DEPARTMENT of AGRICULTURE and NATURAL RESOURCES

October 24, 2022

We have conducted a review of the supplemental information for Wharf Resource's Large Scale Mine Permit application for the proposed Boston Expansion Project received by email on October 5, 2022, October 13, 2022, and October 17, 2022. Please take time to review the following procedural completeness and technical comments and make the necessary corrections to your mine permit application.

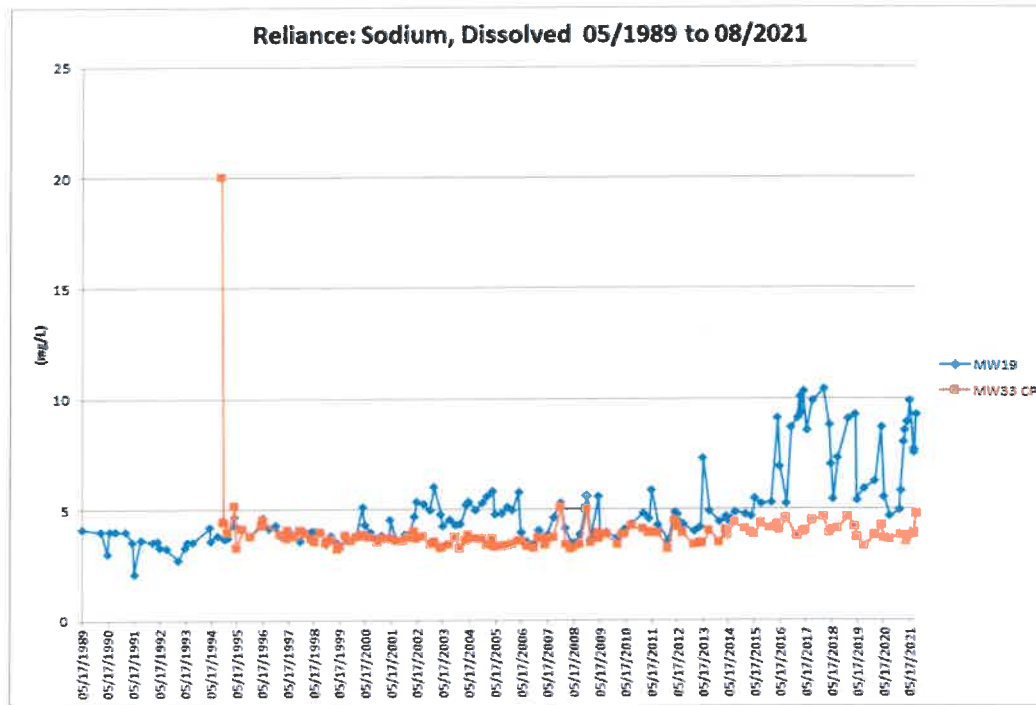
15. Appendix F, Groundwater Characterization Study, Section 3.5.2: The report states “Sodium values have had minor fluctuations. The increases and decreases at MW-33 and MW-19 mirror each other.” When a historical overview of the data is reviewed this statement appears to be incorrect and in fact there appears to be a marked increase in sodium values within MW-19 as compared to MW-33 over the past five years. See graph below.
